RE: SUBMISSION TO SSD-82395459 at Nos. 3A, 3B, 5A and 7 Burgoyne Street, Nos. 1 and 3 Pearson Avenue and No. 4 Burgoyne Lane, Gordon

ATTACHMENT 1

Ku-ring-gai Council's objection to SSD- 82395459 at Nos. 3A, 3B, 5A and 7 Burgoyne Street, Nos. 1 and 3 Pearson Avenue and No. 4 Burgoyne Lane, Gordon

Figure 4: Excerpt of Ground floor plan showing areas shaded green

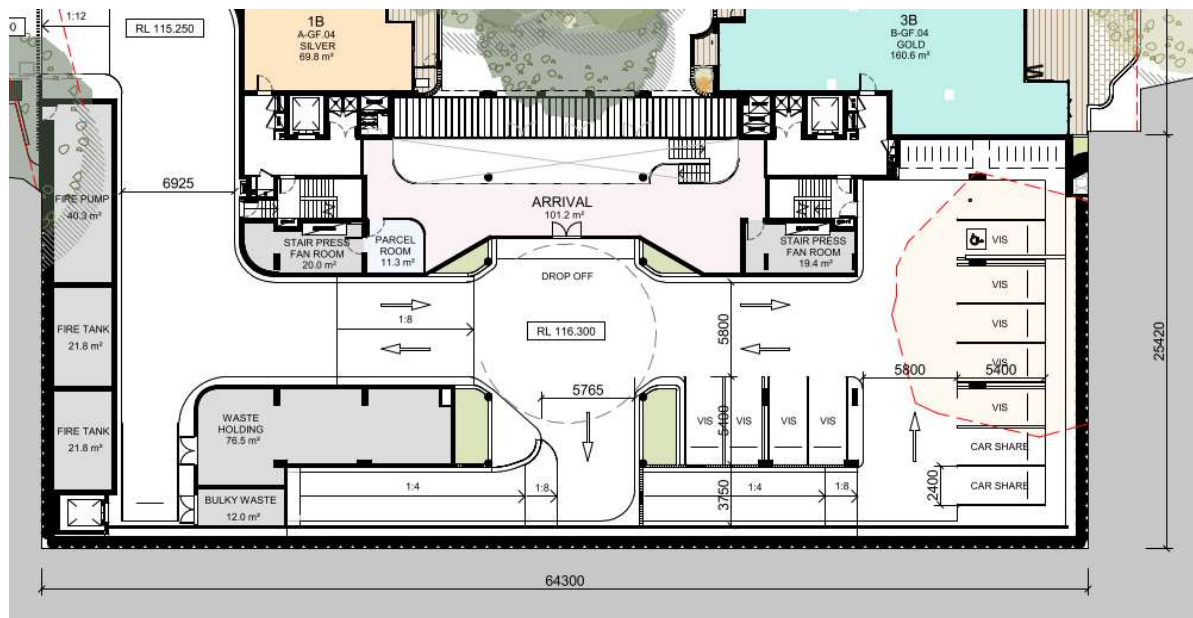
Further, the GFA plans are not to a legible scale and concern is raised that GFA may not have been calculated correctly. Areas to check include: the thickness of walls to common vertical circulation such as lifts and stairs (where not external walls), the thickness of walls to risers, internal walls of areas used for plant/services with common lobbies and the areas shaded green at Ground floor level (**Figure 4**). The cumulative GFA of these features is likely to be significant.

To assist in verifying the GFA, clearer GFA plans should be provided as well as additional sections and an overlay to verify the extent of basement as defined.

Figure 6: Proposed Section through the Site (excerpt from plans by Marchese Partners)

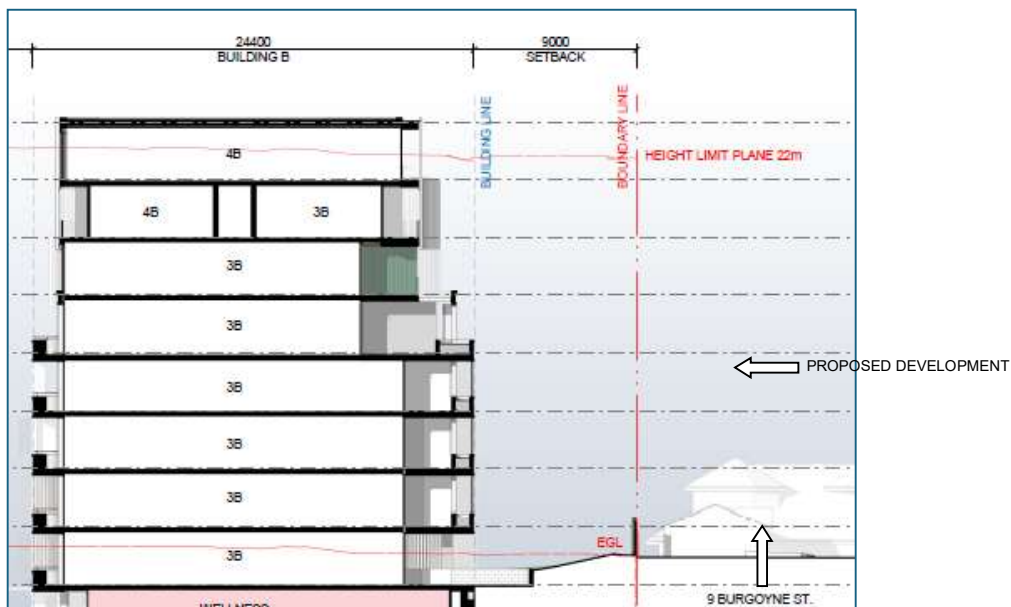
The proposed development addresses the adjoining heritage items and HCA with its eight level scale, dominating over the predominantly single storey scale of the majority of the houses in the area (**Figures 6 and 7**).

Figure 8: Examples of intrusive forms and proportions (excerpt from plans by Marchese Partners)

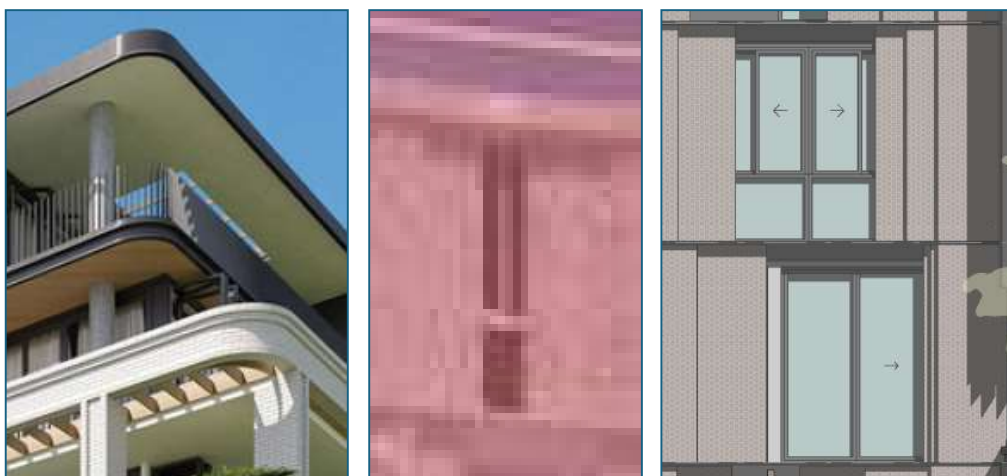
- The proportions of the proposed windows have a base/height ratio of 1:3 to 5:2, which is strikingly differing from, and visually incompatible with the traditional ratio of approximately 1:1.618.
- The fenestration pattern is not aligned. This gives a visually distracting and intrusive fenestration pattern, which is visually incompatible with the traditional imagery.
- The proposed development has an incoherent form with deep recesses, and floor plates and awnings with rounded corners. This creates imagery which is intrusive to the adjoining and adjacent items and the HCA (**Figure 8**).

Figure 12: Comparison between KDCP controls and proposed setbacks.

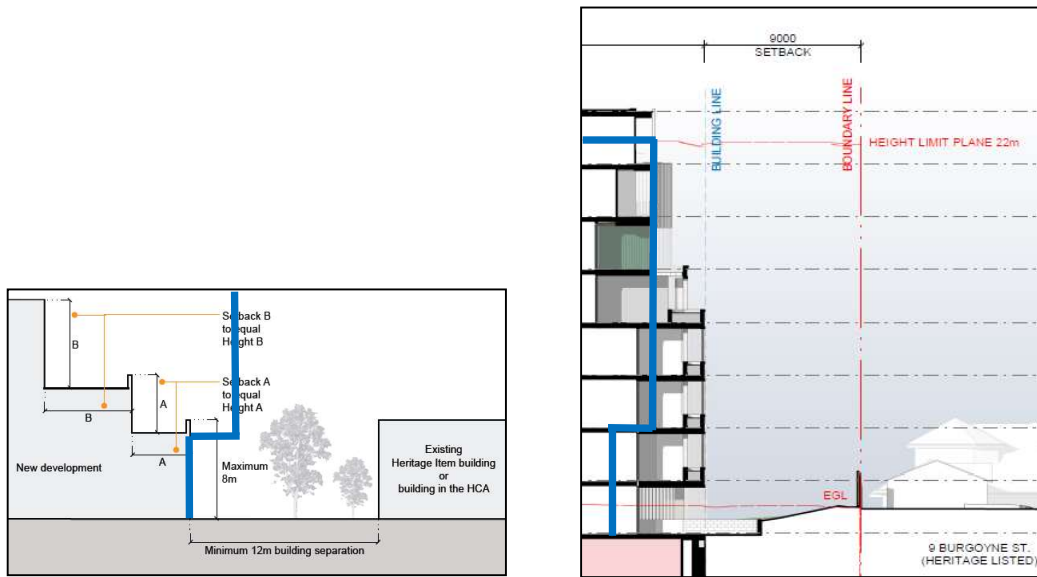
- there is no minimum 12m building separation to the heritage item or buildings in the HCA as per KDCP Figure 19D.2-1 (**Figure 12**); and
- the proposed building mass above 8m high from existing ground level is not stepped back an additional 6m from the heritage item as per Figure 19D.2-1 in the KDCP (**Figure 12**);

Left: Side setback of proposed development (blue line) exceeding permissible in KDCP Figure 19D.2-1.

Right: Section of the proposed development, exceeding permissible setbacks (marked with a blue line).

Figure 14: Excerpt from arborist's report highlighting in yellow inappropriate tree removal and trees likely to be impacted

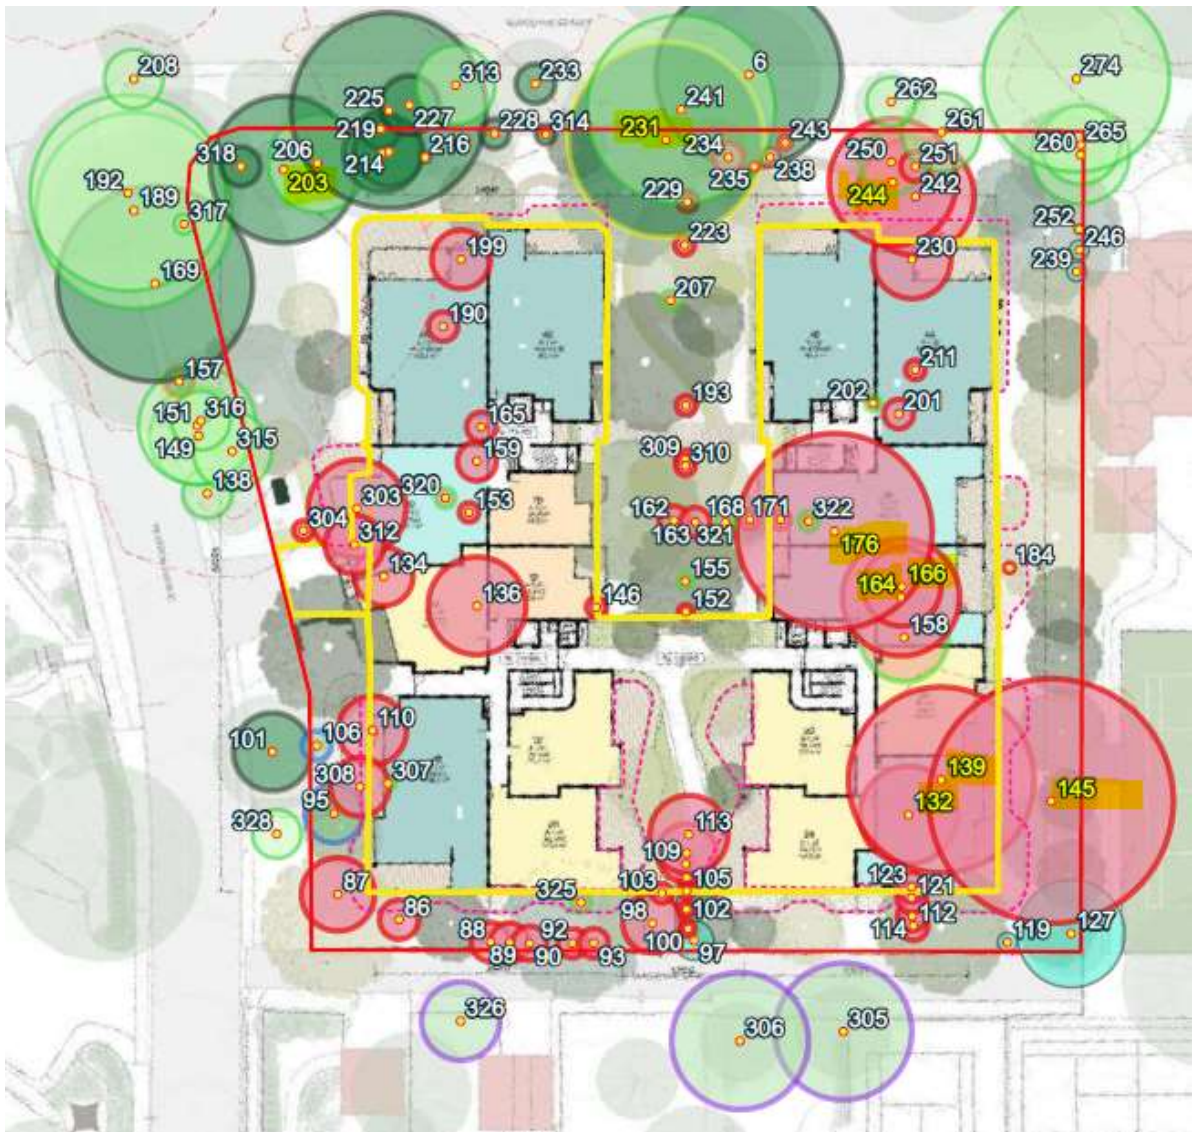
The trees proposed to be impacted or unnecessarily removed by the proposed development are shown in **Figure 14** below (tree numbers highlighted in yellow):

Figure 15: Required sight triangle

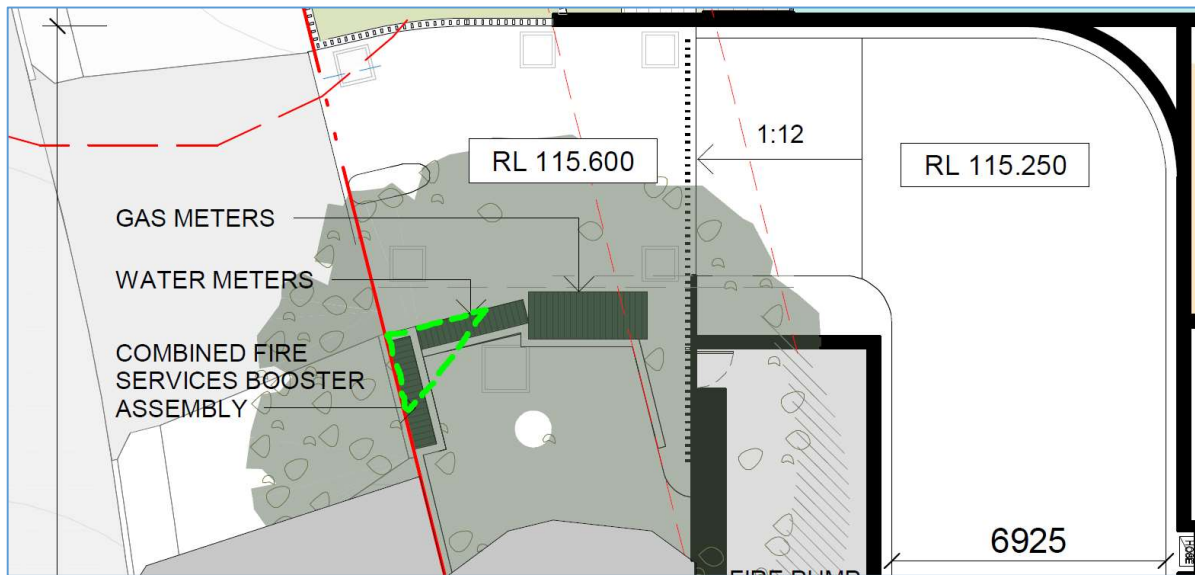
Despite the footpath being behind the kerb, it would still be possible to walk along the boundary. Therefore, it is still considered there should compliance in the provision of the 2m x 2.5m sight triangle as per AS2890.1 (shown in green below in **Figure 15**):

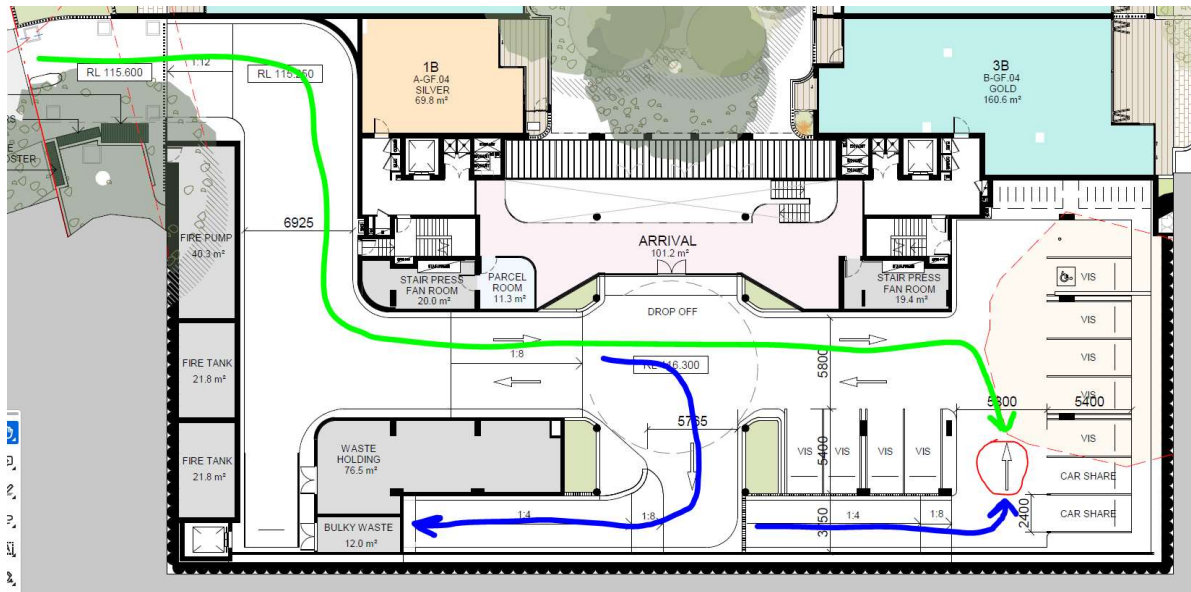
On the Ground Floor level, the two car share parking spaces and one visitor car parking space are located in front of a roadway marked as One Way. The car share spaces and visitor space technically cannot be accessed directly from the car park entry (shown in green) due to the road markings indicating traffic flow in the opposing direction (circled in red in **Figure 16**):

Figure 17: Undesirable visitor parking location

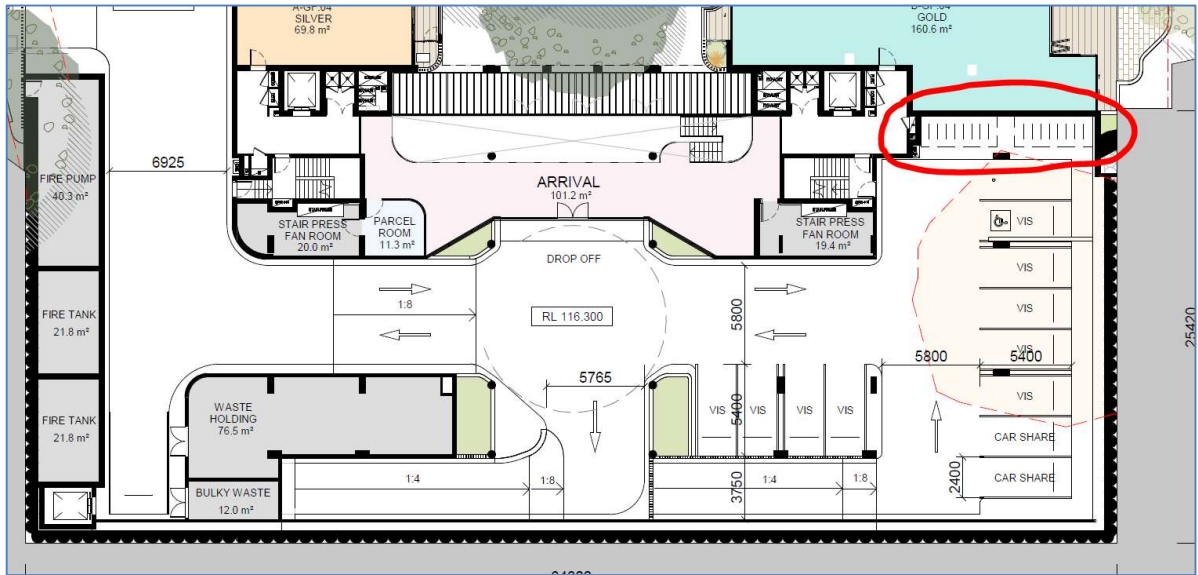
18 visitor bicycle parking will be located on the Ground Floor level, at the far end of the car parking area (circled in red below **Figure 17**):

This location is considered to be too concealed and not offer enough passive surveillance. For ease of access and improved passive surveillance, it is recommended that the visitor bicycle parking be relocated to street level and spread across both pedestrian entrances from Pearson Avenue (as shown in red in the landscape plan extract below **Figure 18**), in accordance with AS2890.3:
